HARTING Product Change Notification

PCN/18/015/C+N

Title: D-Sub plastic hoods for spring or slide locking - External

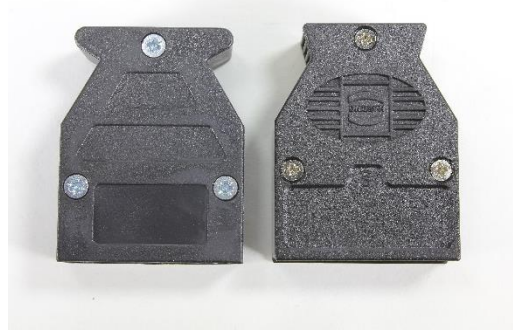
- HARTING-Logo:

Old: no HARTING Logo

New: molded HARTING Logo

(Image shows the 9-pole plastic hood and is for illustration purpose only)

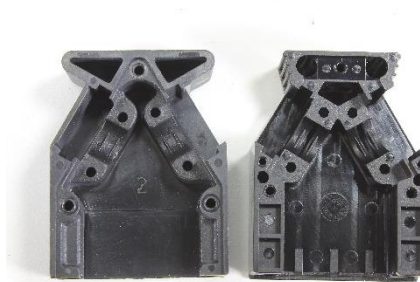
- Different inner shape for optimized molding

Old:

New:

(Image shows the 9-pole plastic hood and is for illustration purpose only)

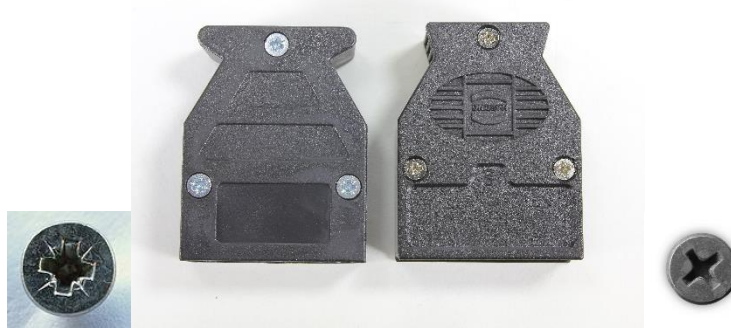
- Kind of screw head:

Old: Cover screws with Pozidriv head (tool PV1) packed in the set

New: Cover screws with Phillips head (tool PH0) packed in the set
